SUBJECT: SUBMITTAL OF REFERENCE DOCUMENTS RELATED TO EA-11-018 FOR BROWNS FERRY NUCLEAR PLANT UNIT 1, DOCKET 50-259

**TVA Response to NRC Questions
Dated 3/31/11 on 1-FCV-074-66**

Browns Ferry Unit 1 FCV-074-066 RHR Outboard Injection Valve Failure NRC Questions (#2)

BFN 1-FCV-74-66 Valve Failure
NRC Follow-up Questions - April 18, 2011

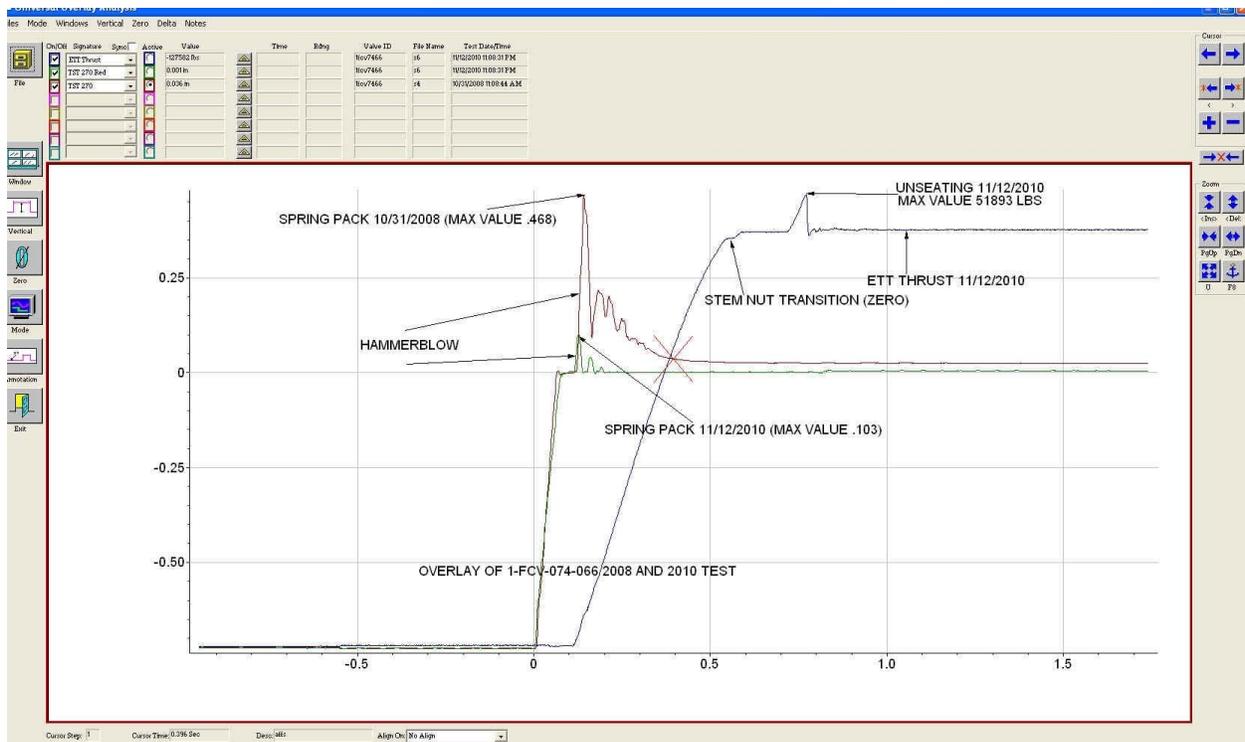
- 7) *There is conflicting data with respect to the history predictive monitoring data table on page 67 of the RCA report and the supplied MOVATS test data traces. For the failed valve 1-FCV-074-066 test on November 2008, it is reported in the history data as no unseating force seen. However, the MOVATS test data supplied with the overall Browns Ferry evaluation indicates otherwise. There is an open stroke spring pack deflection overlay of test data curve noted for valve 1-FCV-074-066 and valve 1-FCV-074-052. Both spring packs have a deflection thus indicating unseating force. 1-FCV-074-066 spring pack has a greater deflection than 1-FCV-074-052. Estimated force for pullout for valve 1-FCV-074-066 is well over 150,000 lbs of thrust based on Limitorque spring pack curve for the lightest pack available. The MOVATS curve date is 10/31/2008. There is also a MOVATS overlay comparison of current values for valves 1-FCV-074-052 and 1-FCV-074-066 on the same date. The current value for 1-FCV-074-052 has a spike representing the unseating but there is no spike on current trace for valve 1-FCV-074-066. Was the spring pack data taken the same stroke as the current data? If the current data was obtained after the spring pack data, it is possible that this was the point of separation. What is the measured stem factor for this valve? (MOVATS test traces show that an ETT transducer was used so torque and thrust data should be available to determine stem factor). Also, what model spring packs were installed in the actuators for 1-FCV-074-066 and 1-FCV-074-052?*

The spike (maximum deflection) on the 10/31/2008 spring pack curve is an indication of hammer blow and not unseating. Refer to the supplied overlay of test data that compared the spring pack curves between the 2008 and 2010 tests as well as the thrust curve of the 2010 test. Although the vertical axis is not the same (spring pack deflection vs. thrust), the horizontal axis is time for both curves. One can observe that the unseating is much later (well after stem nut transition) than the hammer blow event. The spring pack deflection is such a coarse measurement that one would not expect to observe unseating event. The estimated force of 150,000 lbs of thrust is associated with the hammer blow and not unseating. Therefore, this value is not expected to increase as the COF increases to a plateau over time.

Figure 10 from Southwest Research Report

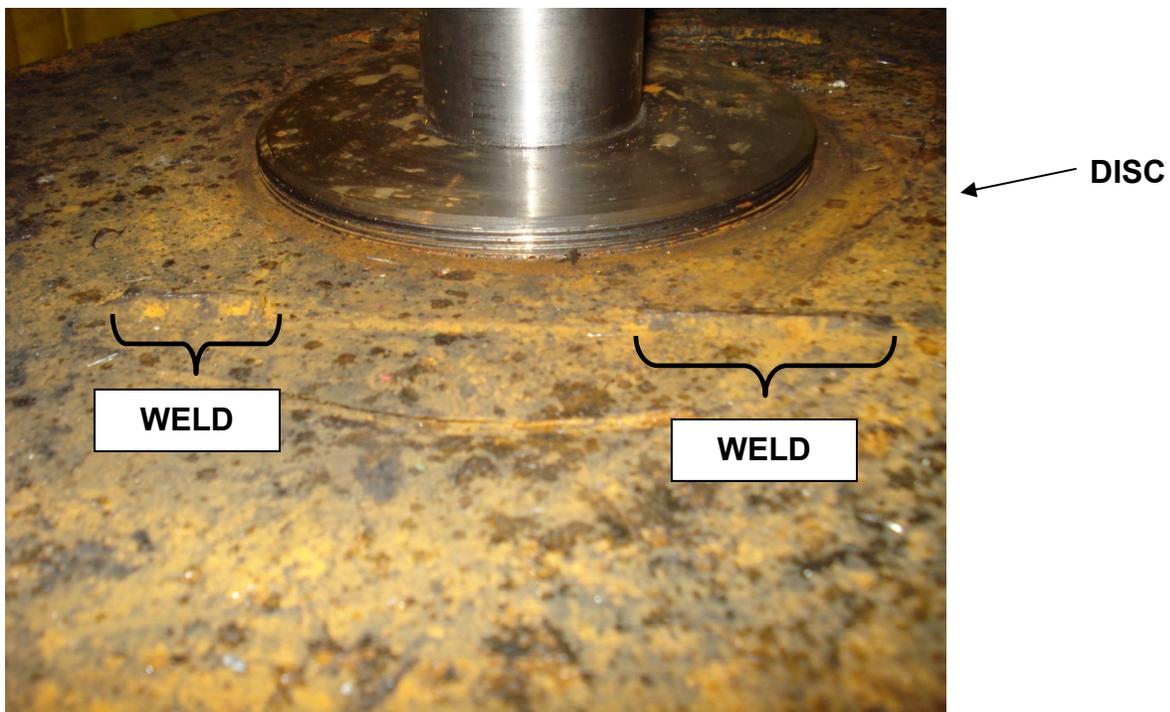
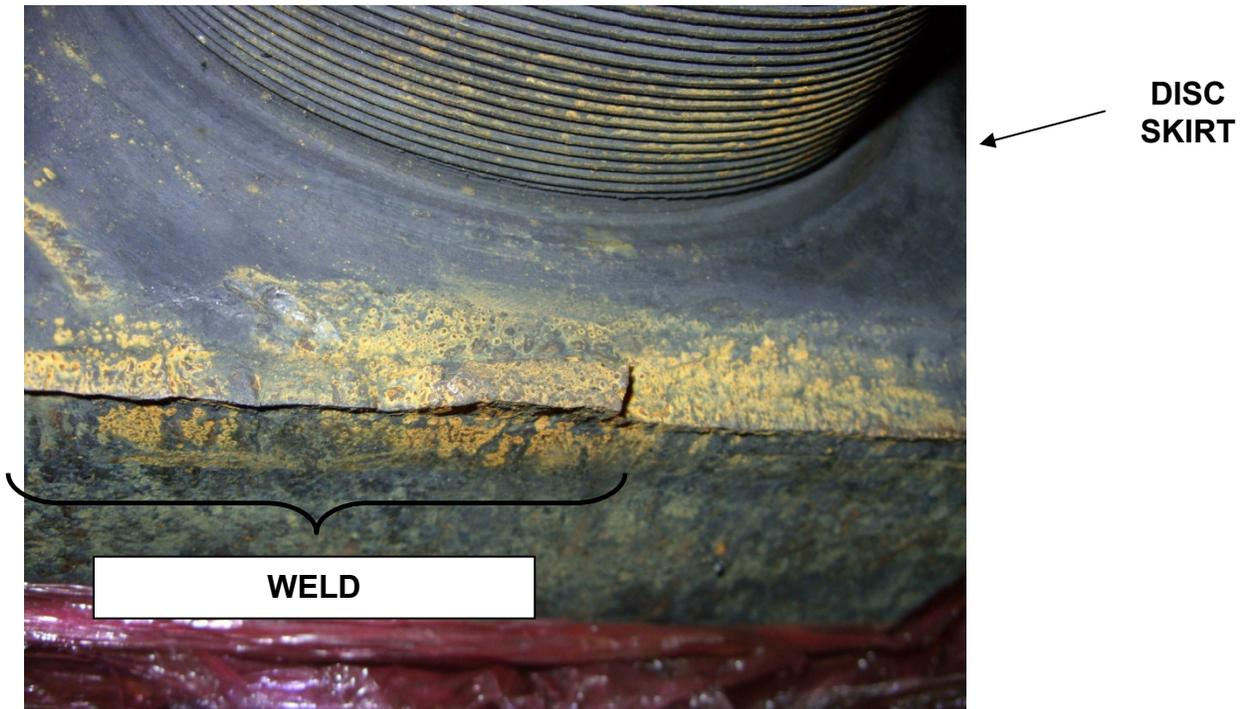
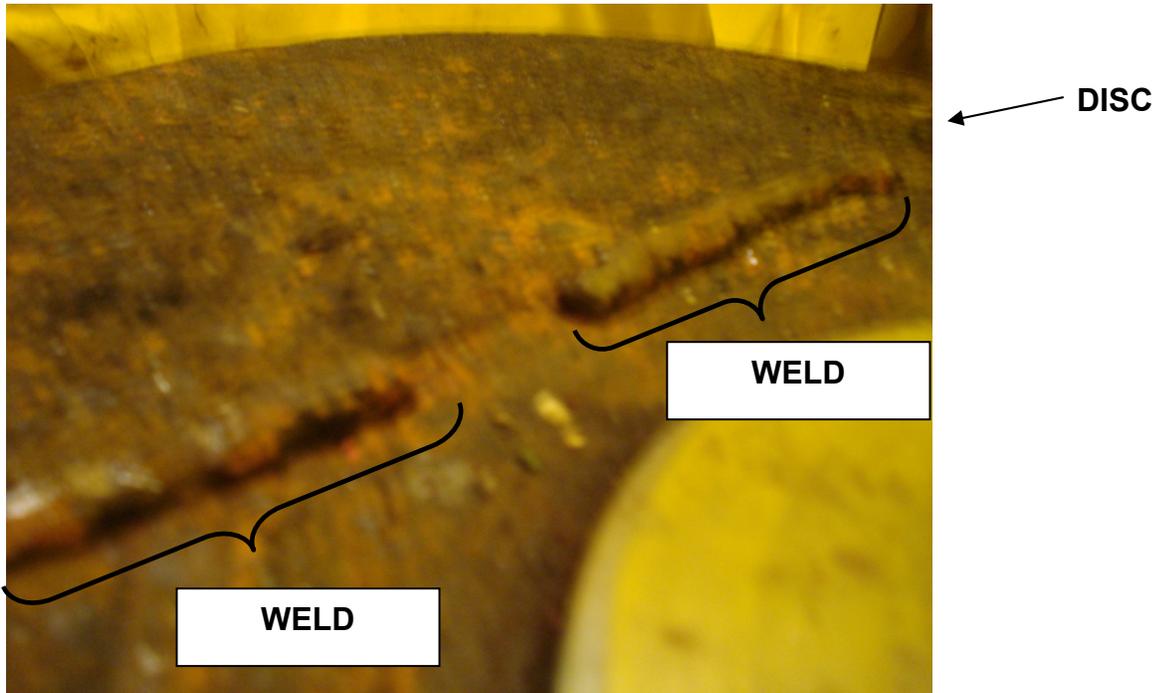
1. *Could the 1-FCV-74-66 valve disc rotate relative to the skirt based on the tack weld condition at the time of discovery?*

1-FCV-74-66 failure occurred due to an axial “pull out” instead of a torsional failure. This is identified by the weld segments left on the disc and disc skirt. The remaining weld segments condition at the time of discovery are not consistent with a rotational event, because any significant rotation would have knocked them off. Typically the valve disk and disc skirt are snug tight prior to welding as discussed in the General Electric Field Deviation Instruction (see the attachment). The thread dimensions according to drawing C-12337-7-3A are 6 3/8 -12 NS-3, which is a pitch of 12 threads per inch which is what was observed, which means in one rotation the linear movement of the skirt away from the disc is 1/12 inch, or 0.08333. Based on the height and orientation of the protruding portions of weld left on the skirt and disc (greater than 1/12”), the protruding weld segments would act as a stop to the rotational motion of the skirt versus the disc. The locations of these protruding weld segments would prevent even one full rotation of the skirt away from the disc. See the pictures below. Therefore, the valve disc could not have rotated relative to the skirt based on the condition of the tack weld at the time of discovery.
